GOVERNMENT OF THE DISTRICT OF COLUMBIA  
DEPARTMENT OF TRANSPORTATION

**MEMORANDUM**

**SUBJECT:** **DDOT Review of ZC 06-04C**, 1600 North Capitol Street NW

Figure 1: Proposed Site Layout and Access. Source: Applicant's Transportation Memorandum. 8/9/13. Symmetra Design.

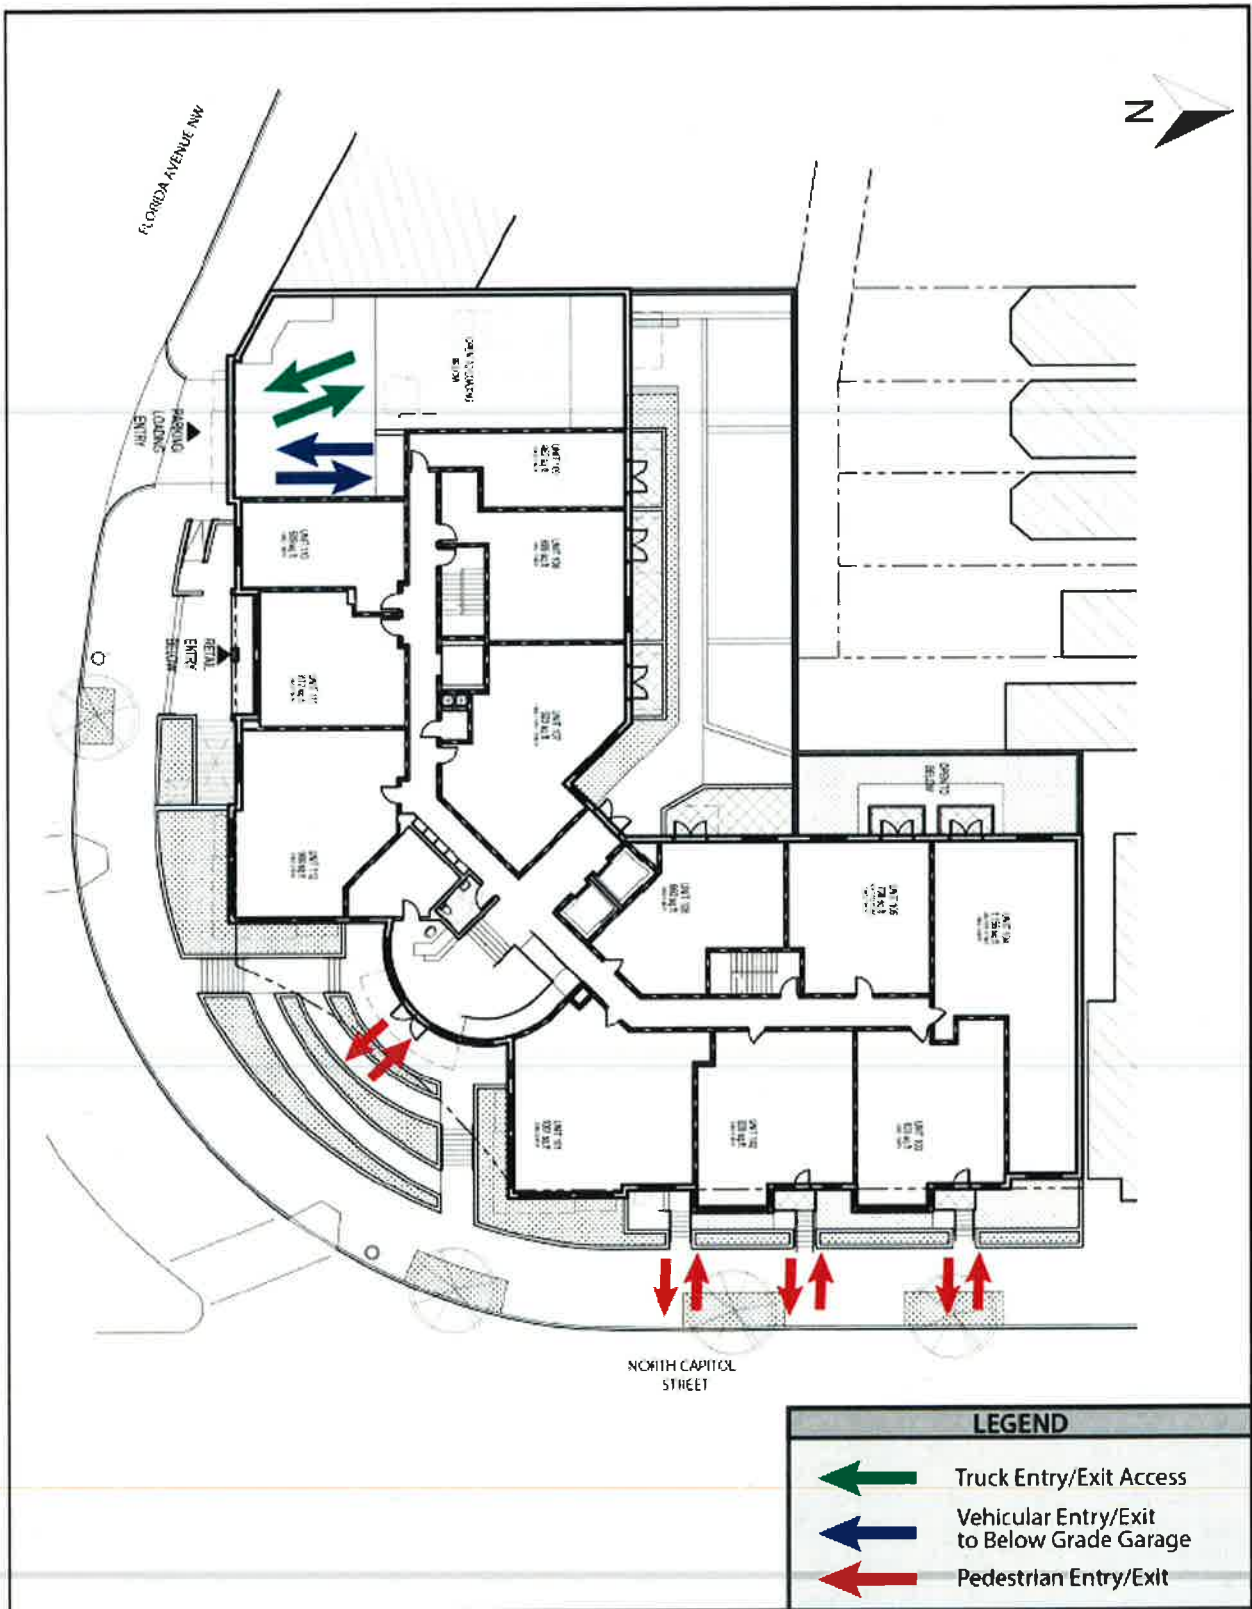
Vehicle and bicycle parking and loading access are proposed to be via a single curb cut on Florida Avenue NW. The curb cut on Florida Avenue NW as envisioned in the previous PUD is inconsistent with DDOT's current standards. The curb cut is located in close proximity to a slip lane that connects southbound North Capitol Street to westbound Florida Avenue/Q Street, which creates safety concerns. Additionally, the design of the curb cut requires truck backing movements across public space thereby exacerbating safety concerns. Because the Applicant is seeking to modify a previously-approved PUD, DDOT and the Applicant coordinated on enacting measures that will improve the safety and operations of the curb cut. The Applicant has agreed to the following:

DDOT also requests that a loading management coordinator be a condition of Zoning Commission approval in order to prevent truck queuing and to help guide trucks' back-in movements to eliminate conflicts with pedestrians and bicyclists.

The specific operations of the curb cut will be addressed during DDOT's public space permitting process. DDOT may request additional restrictions or operational constraints during permitting. Supplementary local mitigations such as signage and flex posts may be required.

- Loading management
  - Delivery days/hours: Residents will be required to schedule use of the loading berth and move-ins would only occur during weekday off-peak hours and weekends. Proposed weekday hours are from 10:00am to 2:00pm and after 7:00pm and on weekend hours are from 7:00am to 7:00pm.
  - Truck size: Trucks larger than 30 feet will be prohibited.
- Curb cut restrictions
  - The curb cut will be restricted to right-in/right-out movements. No left turns in or out of the site will be allowed.
